3 Volt Intel[®] Advanced+ Boot Block Flash Memory

28F800C3, 28F160C3, 28F320C3, 28F640C3

Specification Update

Order Number: 297938-014

2. 28F320C3xC Reset Failure

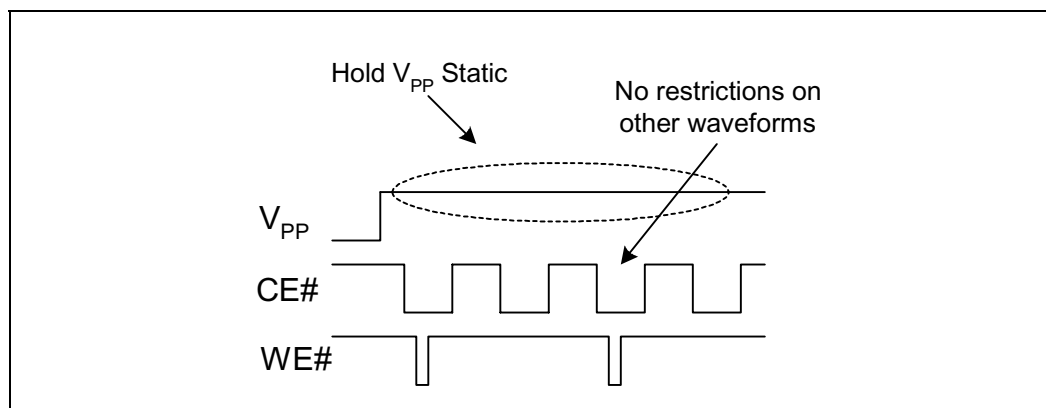
Problem: The 0.18 μm 28F320C3xC devices can unintentionally reset under certain conditions where V_{pp} toggles.

Implication: When the reset occurs, any command being executed is interrupted and the flash switches to read array mode.

Workaround: There are four workarounds for this erratum:

- 1) Tie V_{pp} to V_{CC} ;
- 2) If the third and forth digits on the top side FPO mark (third line) is equal or greater than “23”, then V_{CC} may be set from 2.7v to 3.3v. V_{CC} must not exceed 3.3v
- 3) Set V_{pp} to a static high or static low level as shown here; and

Figure 1. Workaround Placement

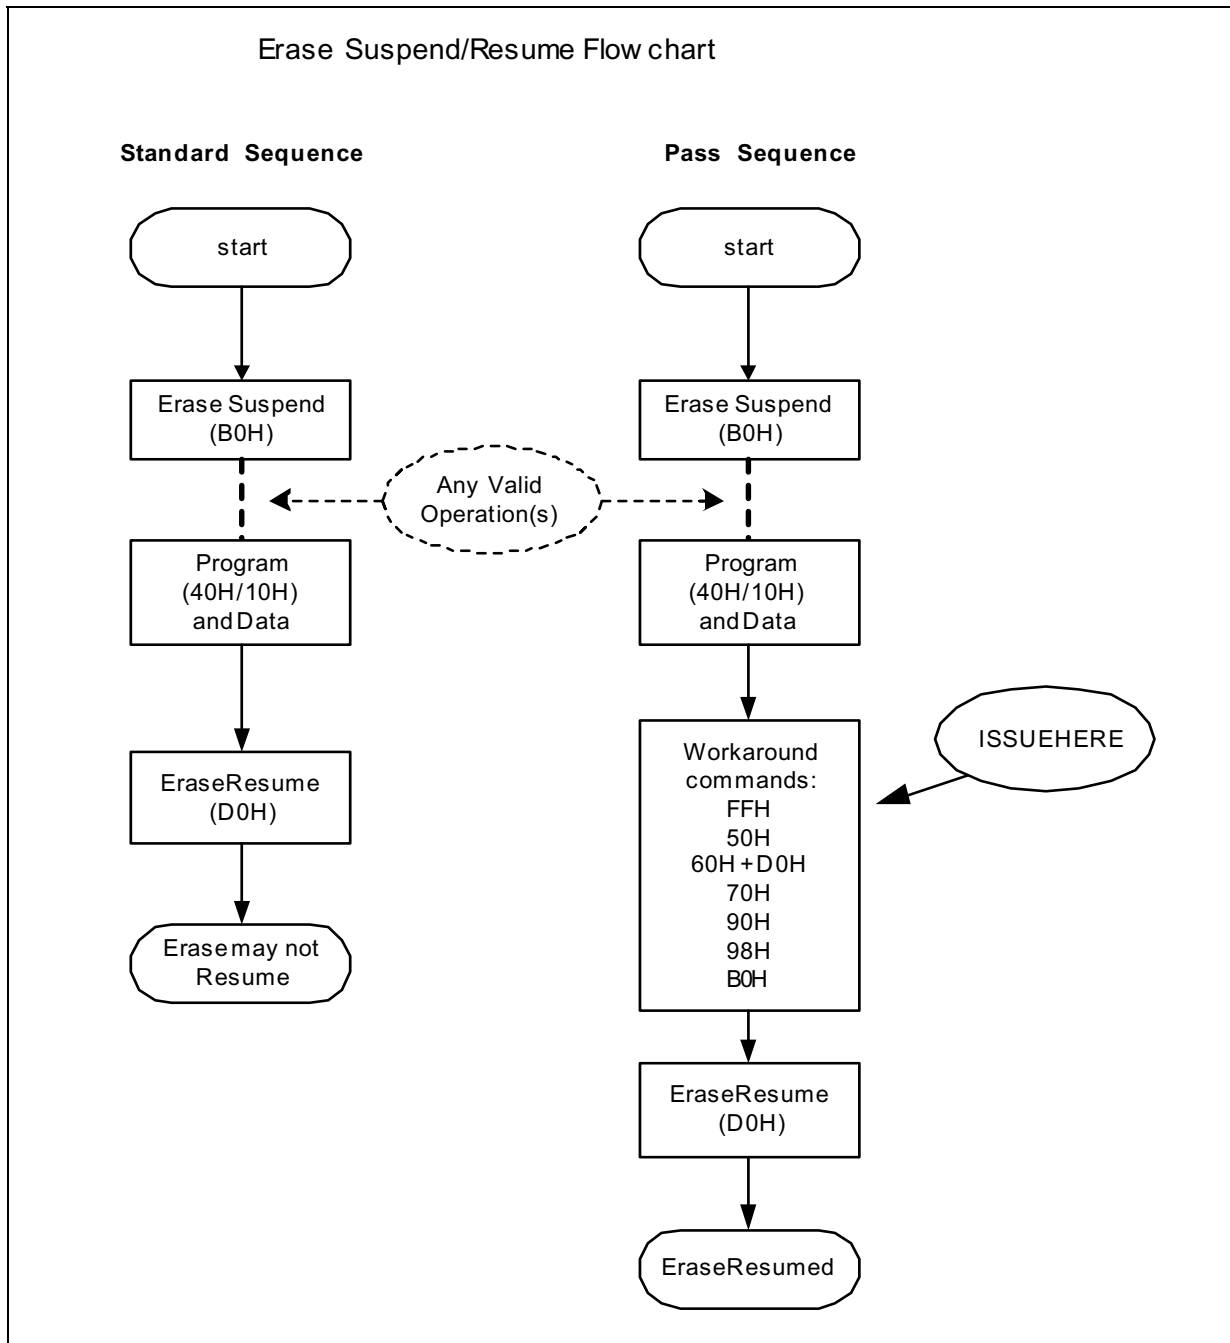
Problem: On the 0.18μm 28F160C3xC devices, a design anomaly was discovered. During an Erase-Suspend operation, if the Program (40H/10H) sequence is executed, under limited conditions the proceeding Erase Resume command (D0H) may not actually resume the device. No customers have reported failures in product applications. Customers who use any version of FDI (Intel Flash Data Integrator) software will not see this issue. If the Read Array command is issued prior to the Erase Resume command, users will not see the issue (typical in XIP applications).

Implication: The Resume Command (D0H) may be ignored by the device and will not correctly resume. The device will appear to remain in suspend (via status register). After a reset of the flash device the status register will clear. This failure has been recreated in a lab environment only.

Workaround: There are 2 workarounds for this erratum.

1. If FDI (Intel Flash Data Integrator) software is used, users will not see the issue.
2. During an Erase-Suspend (B0H), user must issue any of the following commands after issuing the Program (40H/10H) and data sequence but before issuing the Erase-Resume (D0H) command.

5. 28F160C3xC and 28F640C3xC Lock/Unlock/Lock-Down Operation

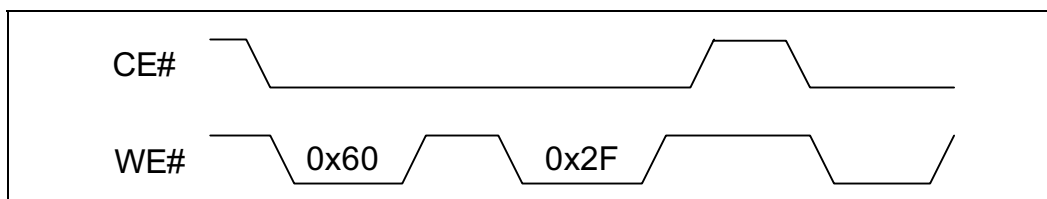
Problem: On the 16Mb and 64Mb 0.18µm devices, if CE# is deasserted after any block lock operation and before the next write sequence, the part may perform the same operation on additional blocks. (See waveform below.)

Implication: When CE# is deasserted after performing a block lock operation to a specific block and prior to the next write sequence, other blocks may perform the same operation.
